CERTIFICATE OF APPROPRIATENESS

Property: 8322 Glenloch Dr., 8,120 SF Lot; 1,482 SF House

Proposal: Alteration -new carport, new windows in front elevation, gable fenestration removed

Recommendation: Denial - does not satisfy criteria and issuance of a Certificate of Remediation to remove the carport, remove the 4 front windows and replace brickwork, and to re-open the front facing gable and install glass, as was originally constructed, final detailing to be approved by staff.

Figure 10 - Existing Front Elevation

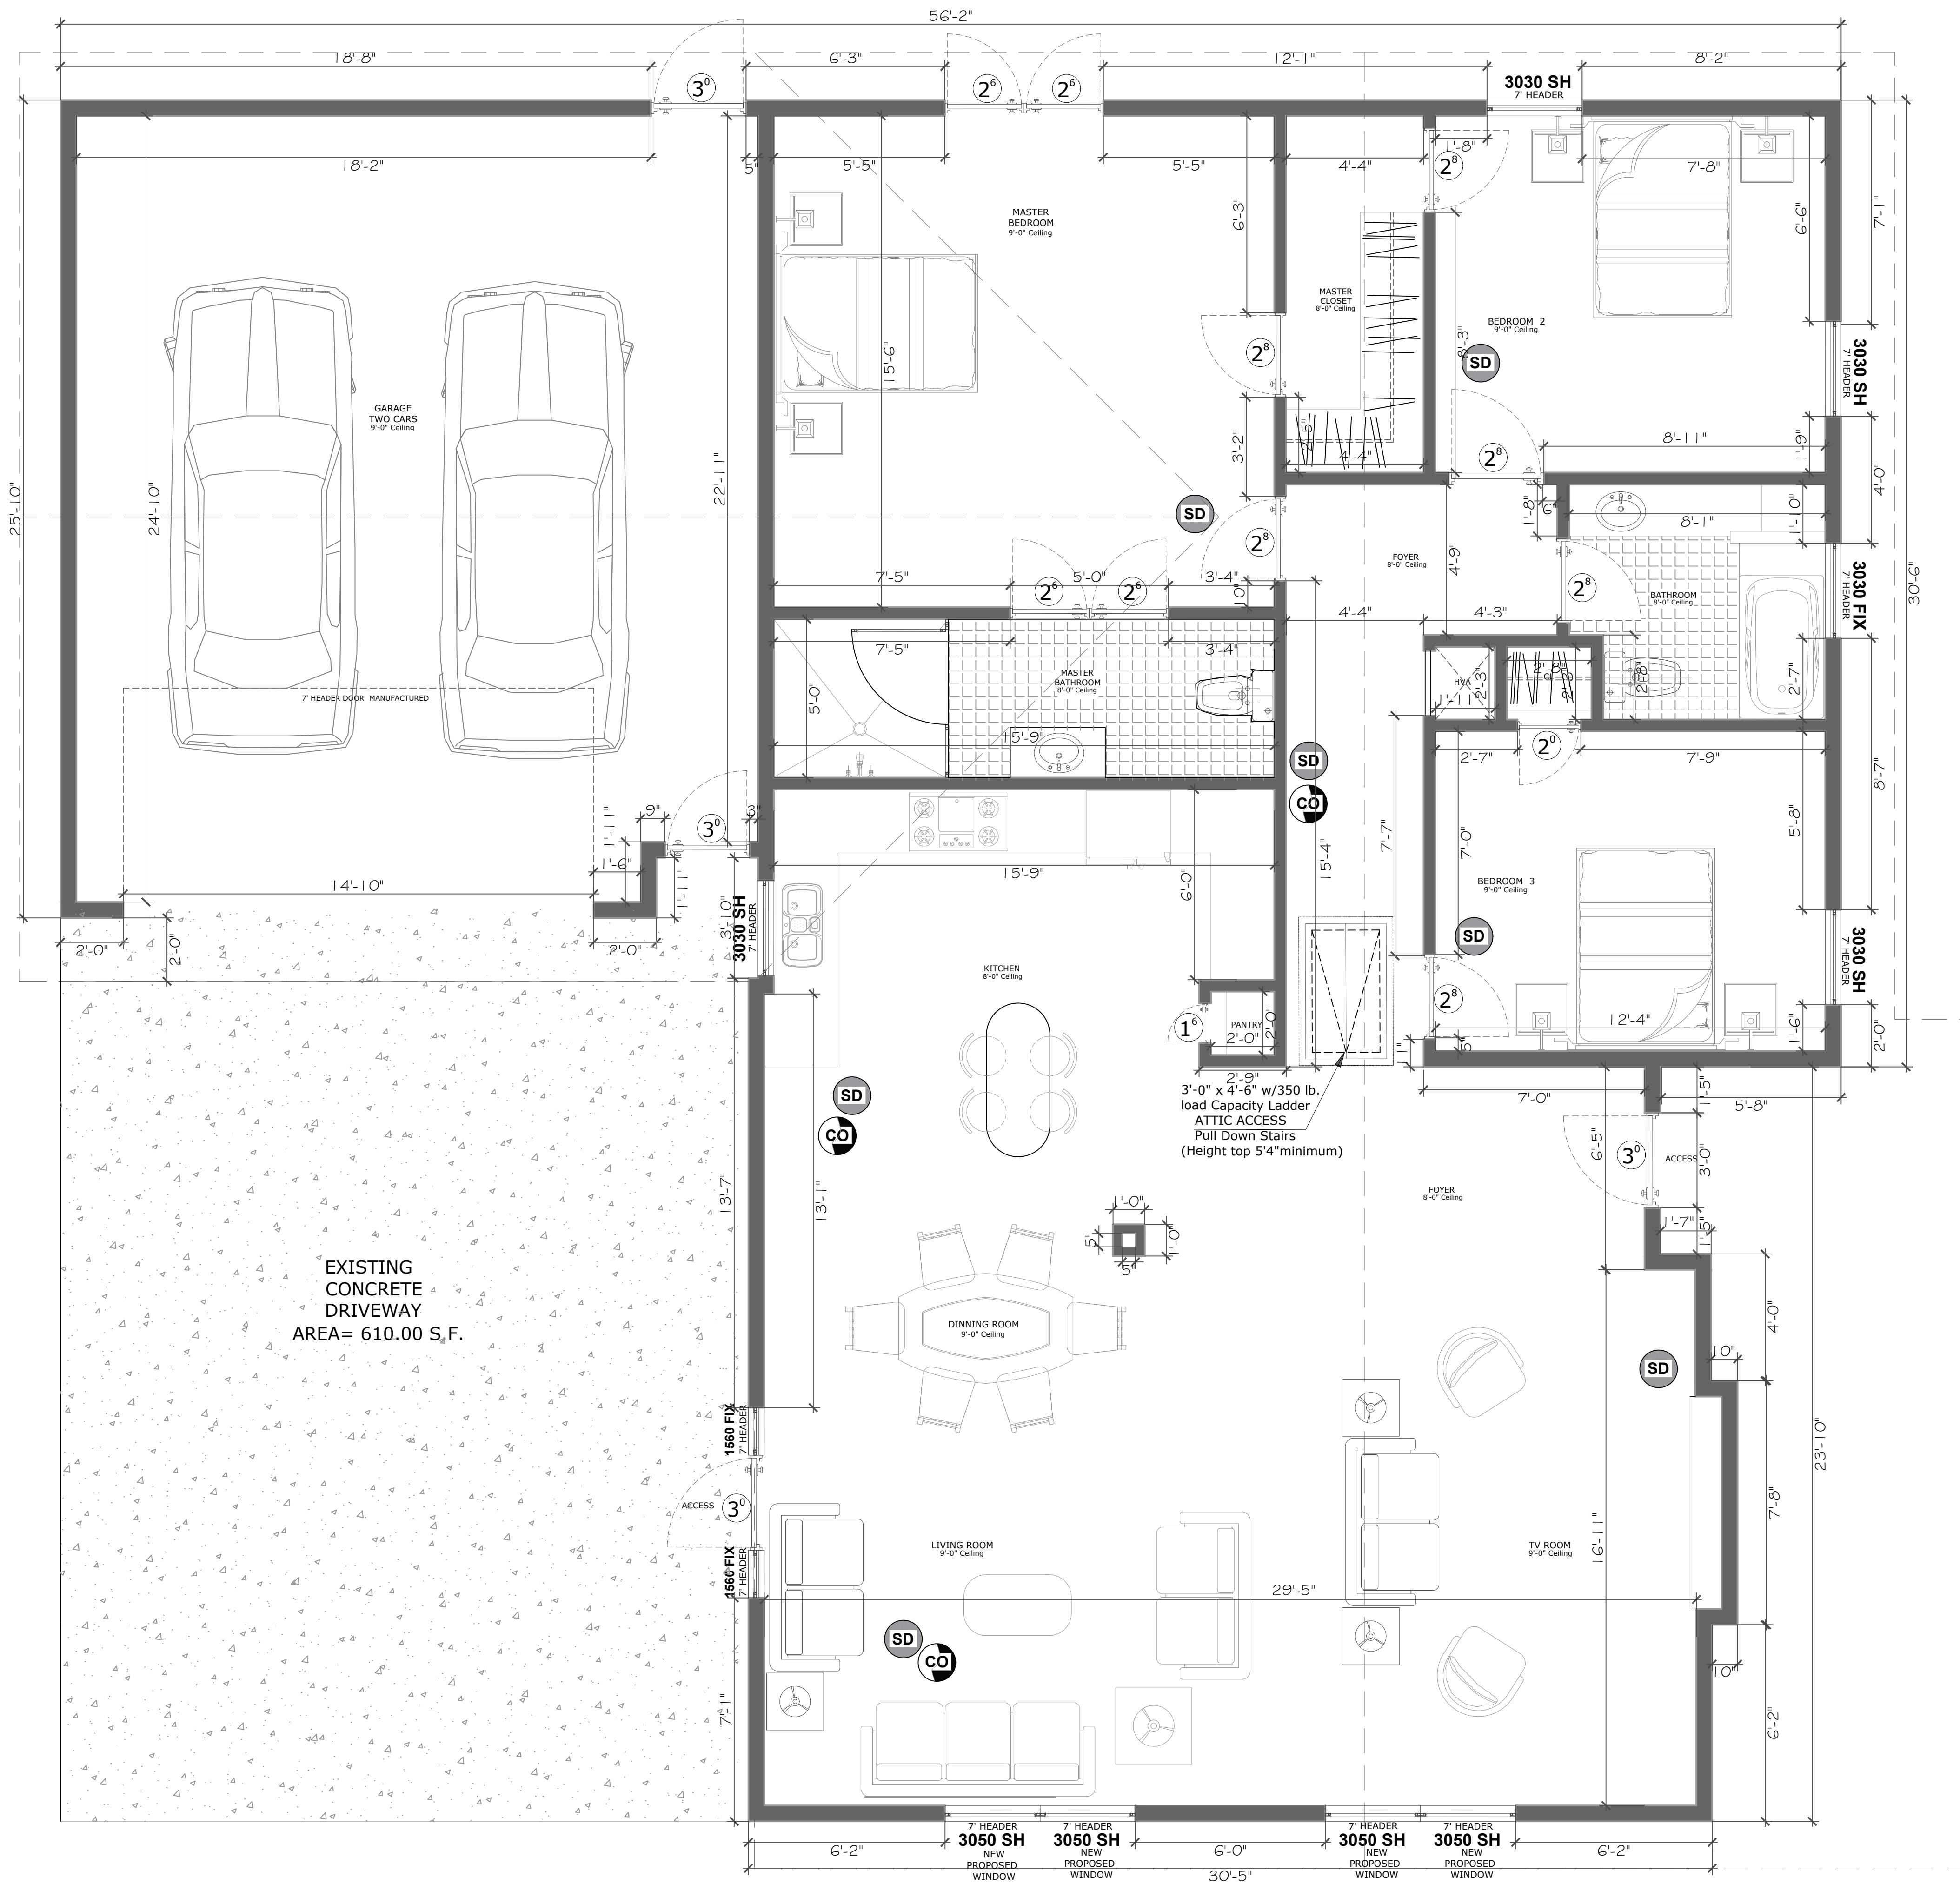
- (9) The proposed design for any exterior alterations or addition must not destroy significant historical, architectural, archaeological or cultural material, including but not limited to siding, windows, doors and porch elements;
The front facing wall has been perforated by the newly installed windows which if removed would not leave unimpaired the essential form of that wall.

Additionally, eave braces were removed.

PLAN NAME: ELEVATION PLAN w/ PROPOSED CARPORT ADDITION	SHEET NO.: A5
	PROJECT: RESIDENTIAL HOME REPAIR & ADDITION	OWNER: ROMERO GERARDO
ADDRESS: 8322 GLENLOCH DR HOUSTON TX. 77061	SCALE: 1/8" = 1'	PROJECT: 00000000

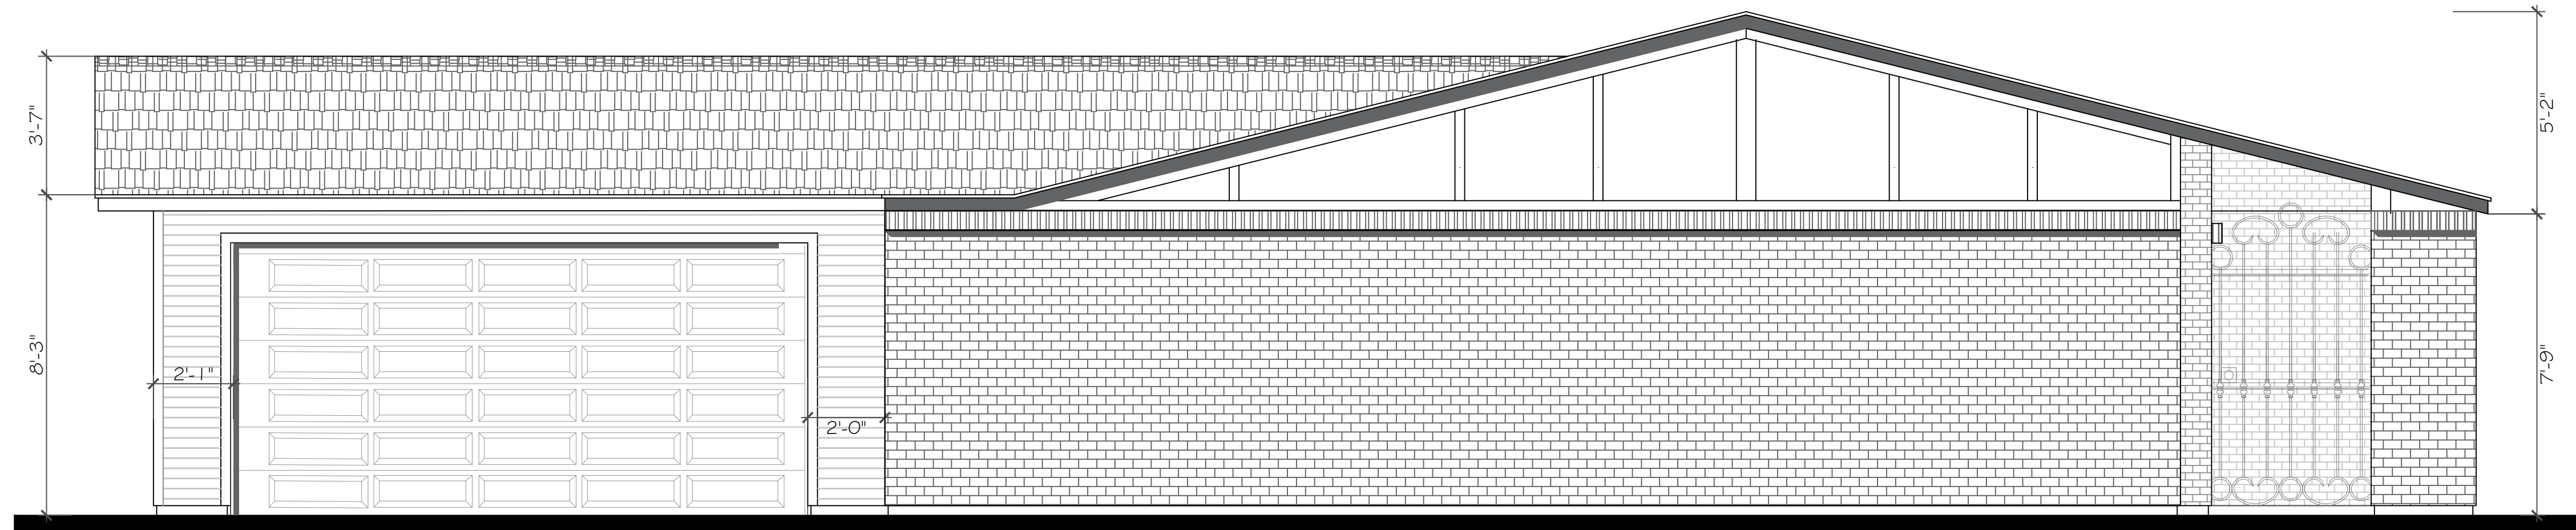
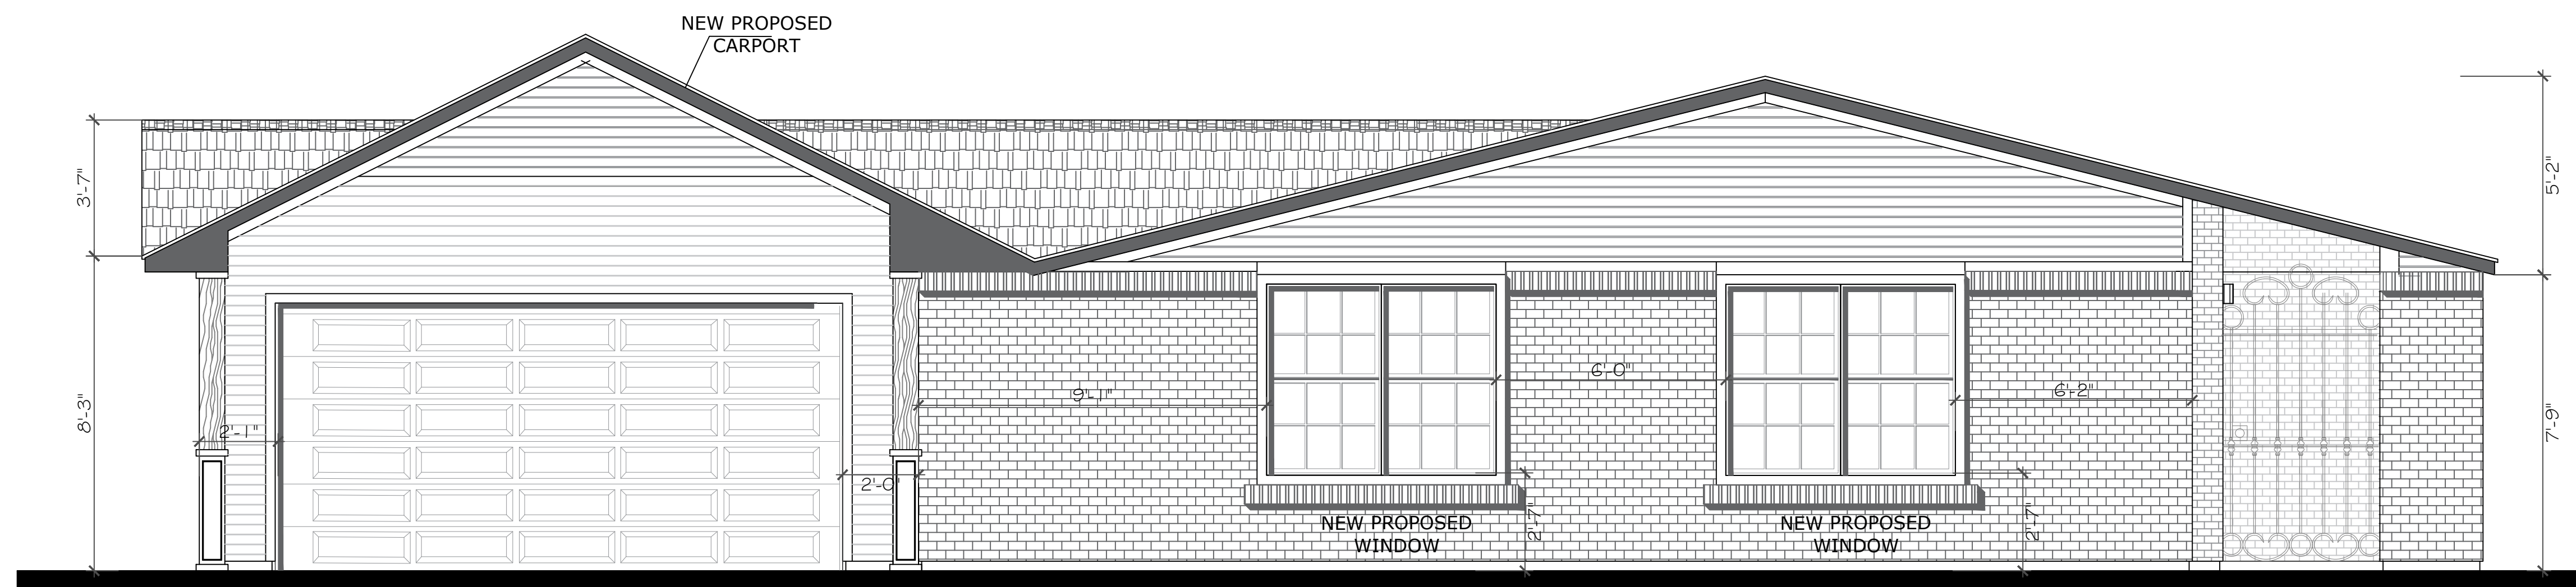
A distinctive stylistic exterior feature of this house is the protruding deep eaves with clearstory in the upper portion of the front wall, the gable. Filling in this cable with cementitious siding does not maintaining this stylistic feature. The deep forward-facing eaves supported with cantilevered 4" x12" timbers were also a defining characteristic. |

- (6) New materials to be used for any exterior feature excluding what is visible from public alleys must be visually compatible with, but not necessarily the same as, the materials being replaced in form, design, texture, dimension, and scale;
The lapped cementitious siding on the front gable and carport, as well as the white 6/6 simulated divided light windows with the mutons encased between glass, are all not compatible with the replaced materials.

- (10) The proposed alteration or addition must be compatible with the massing, size, scale material and character of the property and the context area; and
The carport that was constructed, both the previous one prior to the fire and the one constructed there today are not compatible with the massing, size, scale material and character of the property nor the context area.
